Work Order ID 117057

Item Name: Fwd Crosstube - High

DRAWING NO. D212-664-141	TITLE XTUBE ASSY (205/212/412 HI FWD)	REV. D	DART AEROSPACE LTD ENGINEERING ORDER		D.E.O. NO. D212-664-141-D-1	SHEET NO. SHEET 1 OF 2	SCALE NTS
DRAWN	CHECKED	MP	MFG. APPR.	APPROVED	MP	DE APPR.	
DATE 11.04.07	DATE 11.04.11		DATE 11.04.12	DATE 11/04/12		DATE 11.04.12

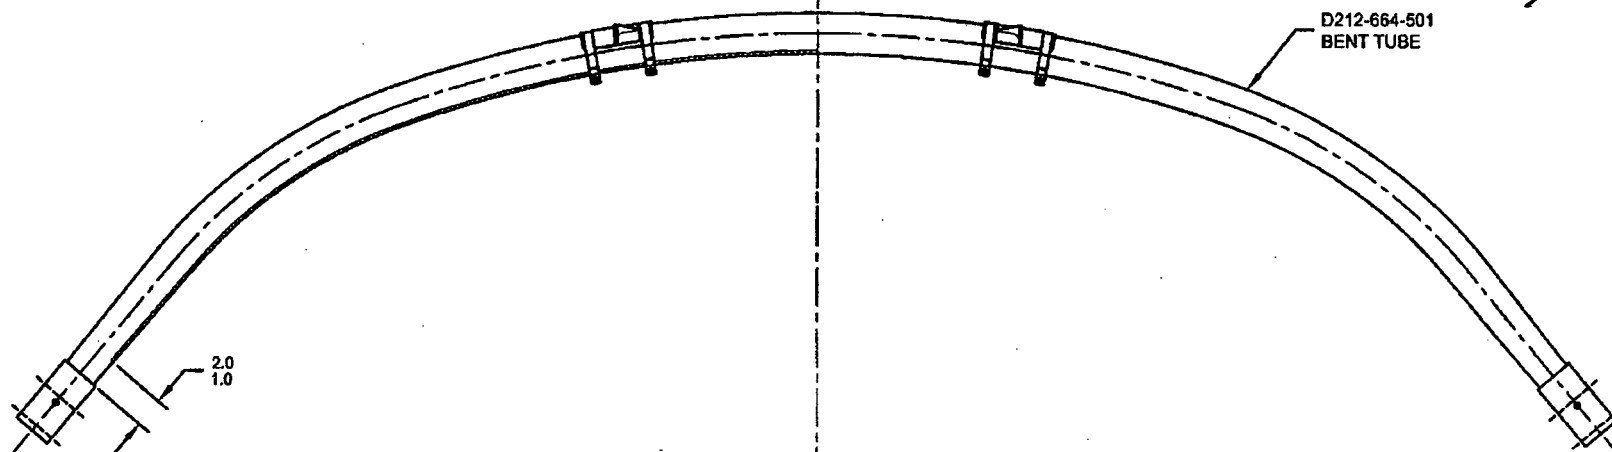
ADD AN INSPECTION WINDOW TO UNDERSIDE OF CROSSTUBE.

NOTES 2 OF SHEET 1 IS AMENDED AS FOLLOWS:

- 2) FINISH: CHEMICAL CONVERSION COAT PER DART QSI 005 4.1
PRIME INSIDE AND OUTSIDE PER DART QSI 005 4.2
MASK UNDERSIDE OF CROSSTUBE AS SHOWN (HATCHED AREA) AND
PAINT OUTSIDE PER DART QSI 005 4.2
REMOVE MASKING AND APPLY CLEAR COAT

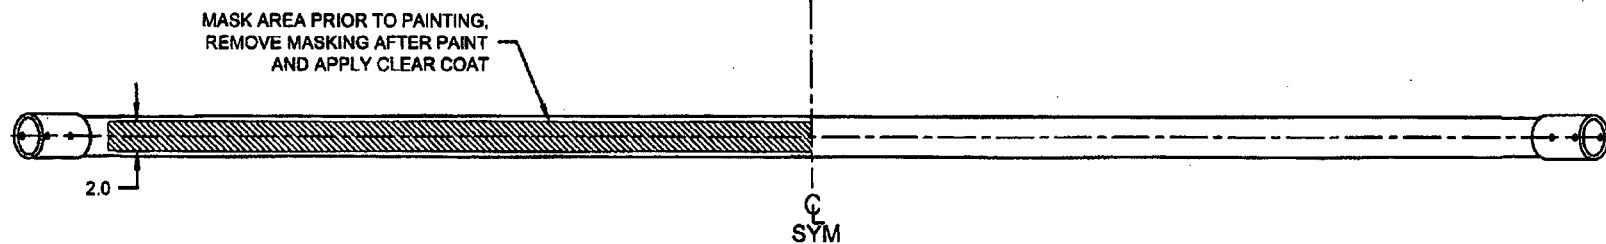
PURPOSE:

REPLACE MAGNOBOND WITH PROSEAL.

NOTE 12 & 15, SHEET 1 IS AMENDED AS FOLLOWS:

- 12) TO INSTALL D2893-1 SUPPORT: ABRASE MATING SURFACE OF SUPPORT AND CROSSTUBE WITH 180-GRIT SANDPAPER AND REMOVE RESIDUE WITH MEK (OR EQUIVALENT). APPLY A 0.04" TO 0.07" THICK LAYER OF PROSEAL 890 CLASS B-2 (OR AMS-S-8802 CLASS B-2) SEALANT TO MATING SURFACE OF SUPPORT.
- 15) TORQUE CLAMPS 80 TO 100 IN-LB. ENSURE AT LEAST 1.5 THREADS SHOWING IN SAFETY AND THAT NUT HAS NOT BOTTOMED-OUT AFTER TORQUING. **PRIOR TO PACKAGING, RE-CHECK TORQUE ON CLAMPS AFTER PROSEAL 890 SEALANT HAS CURED FOR 72 HOURS.**
